OUR REF.NO. 061

M645 SUPER

3 ROLL FILM HOLDER

7 TECHNICAL BULLETIN

SCRATCH ON FILM SURFACE	1/2	87	1
-------------------------	-----	----	---

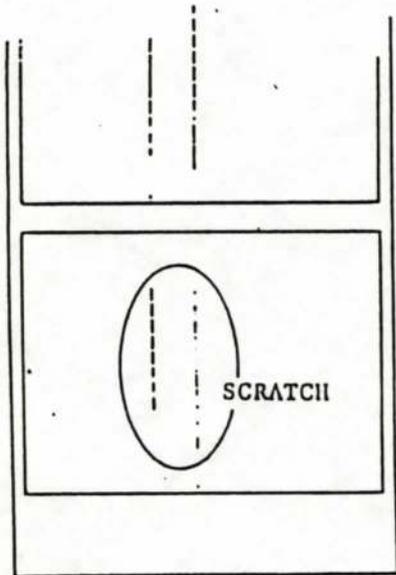
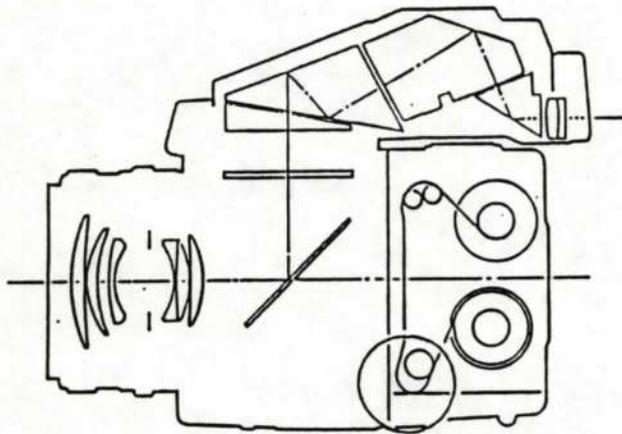
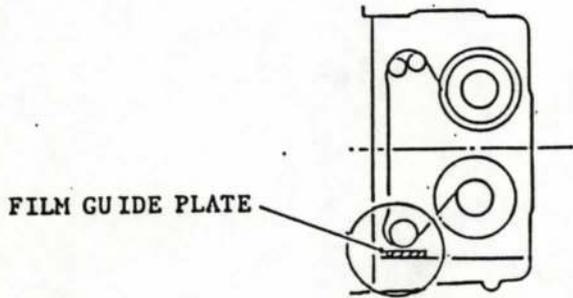
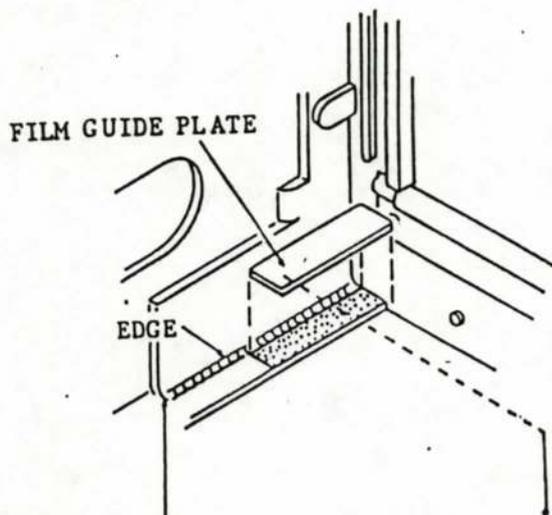
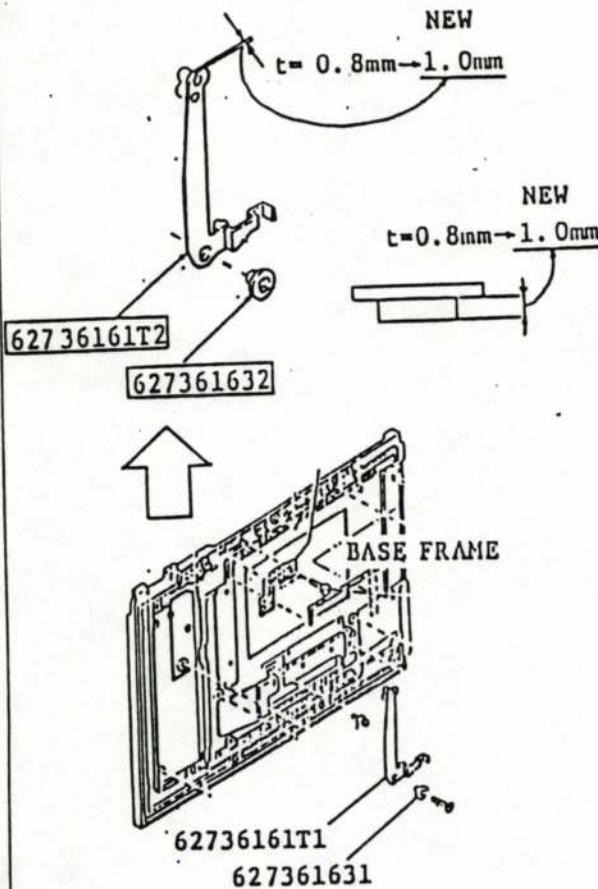
1. PHENOMENON

: Scratch on film surface at the 13th~15th exposure frame.

: Film surface will rub inner wall of film chamber at 13th to 14th exposure frame.

Don't put Film guide plate on body edge.
(Shade position)

- : Apply the film guide plate to each corner
- : New parts No.627041571 Film guide plate.

- : From August,1986.
